PLANNING DEPARTMENT  
Staff Report & Recommendation

Design Review Board

SUBJECT: **DRB24-1078, 1681 LENOX AVENUE**

An application has been filed requesting modifications to an existing two-story commercial building that received Design Review Approval. Specifically, the applicant is requesting Design Review approval for a proposed aluminum screen located on the west and south facades, including one or more waivers.

*Figure 1: Water Feature*

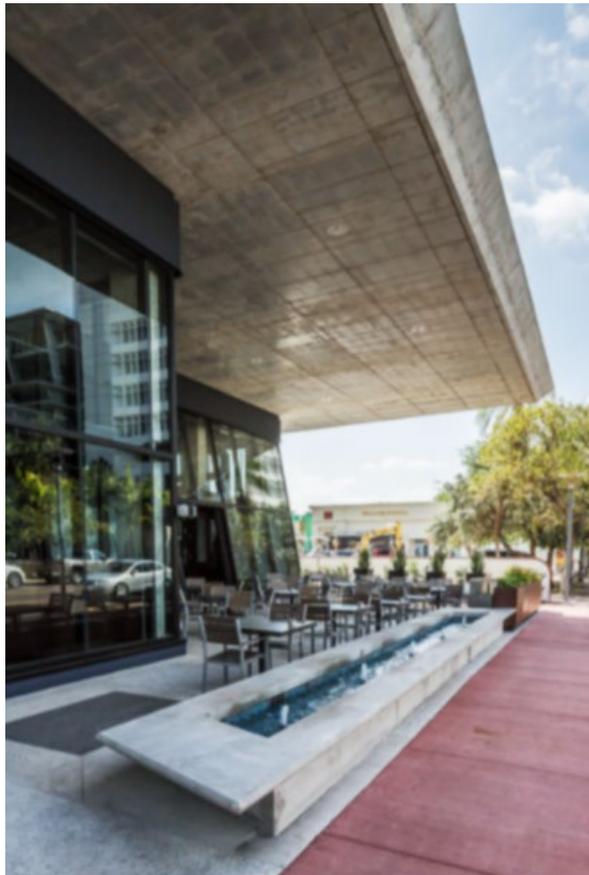
Staff also has a concern with the proposal to remove the existing water feature (see Figure 1 at the end of this report) and instead recommends that the lower section of the screen be repositioned either behind or above the water feature. This would allow for a key feature of the original design to be maintained, while still allowing for outdoor seating. Staff is also recommending that the water feature be operable, including the incorporation of night lighting to enhance the evening appearance.

- c. The existing water feature shall be preserved and be operable, night lighting shall be restored or installed to enhance the evening appearance. in a manner to be reviewed and approved by staff consistent with the Design Review Criteria and/or the directions from the Board.

- d. The lower screen shall be repositioned behind the water feature or above the water feature. in a manner to be reviewed and approved by staff consistent with the Design Review Criteria and/or the directions from the Board.
